## Categorical Exemption Appeal 2655 Broderick Street

**DATE:** February 13, 2015  
**TO:** Angela Calvillo, Clerk of the Board of Supervisors  
**FROM:** Sarah B. Jones, Environmental Review Officer – (415) 558-9048  
Mary Woods – (415) 558-6315  
**RE:** Planning Case Nos. 2014.1497D and 2014.1498D  
Appeal of Categorical Exemption for 2655 Broderick Street  
**HEARING DATE:** February 24, 2015  
**ATTACHMENTS:** Attachment A – January 16, 2015 Appeal Letter from Irving Zaretsky and Engineers: Frank Rollo, Rodrigo Santos, and Paul Cox (The Appeal Letter includes the December 5, 2014 Exemption from Environmental Review)

Re: Planning Commission Hearing on 2655 Broderick  
WJE No. 2009.4685.0

*Figure 1. View of deck stairs and property-line wall*

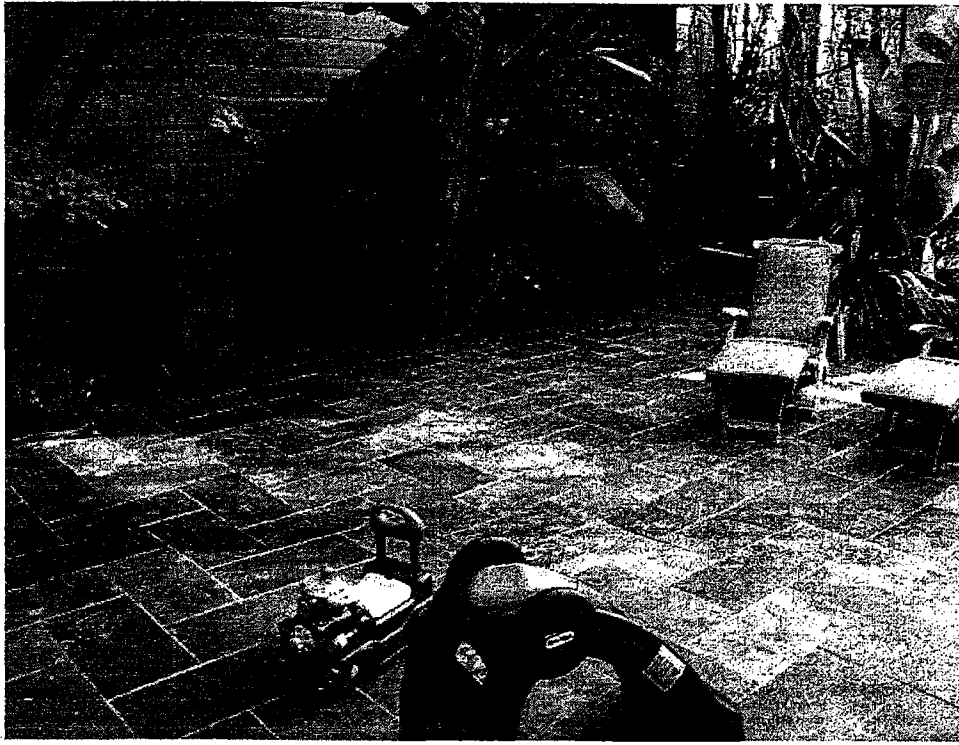
However, potential setback encroachment is not the only reason why this question is before you. When the stairs were installed adjacent to the property line, they were founded on fill that added significant surcharge to the unreinforced concrete foundation wall of 2701 Green. The foundation and stairs themselves also imposed surcharge loads on the foundation wall of 2701 Green. A general view of the back stairs is shown in Figure 1. The additional soil fill and an unpermitted patio has directed water from 2655 Broderick against the walls and foundation of 2701 Green. Lastly, the soil fill was pushed against the wood framing of the wall causing decay of the wood siding and framing, as shown in Figures 2 and 3. The existence and cause of the

In 2010, among other recommendations, I recommended, that the stairs be removed, the wall and framing be repaired, and that the stairs be relocated or reconfigured to conform to various Building, Planning and Plumbing (drainage) Code requirements. My report, dated June 13, 2010 is attached as Exhibit 3. Instead of agreeing to these reasonable recommendations, the Mr. Casey has sought only to get the existing nonconforming construction permitted, leaving the question of repair of the decay 2701 Green and future protection of the wood wall unaddressed.

- Remove the existing deck stairway and foundation.
- Provide access to Mr. Zaretsky's contractors to repair the existing wall decay of 2701 Green.
- Pay for the repair of the decay repair.
- Re-grade the soil adjacent to the property line to remove an average of 18-inches of fill.
- Provide positive drainage for runoff towards 2701 Green.
- If the stairs are to be reinstalled within the zone of influence of the retaining wall, design the footings so that they will not surcharge the wall.
- Landscaping must be kept small and held away from the property line wall.
- Irrigation must be drip or far enough from wall to not spray water on the wall
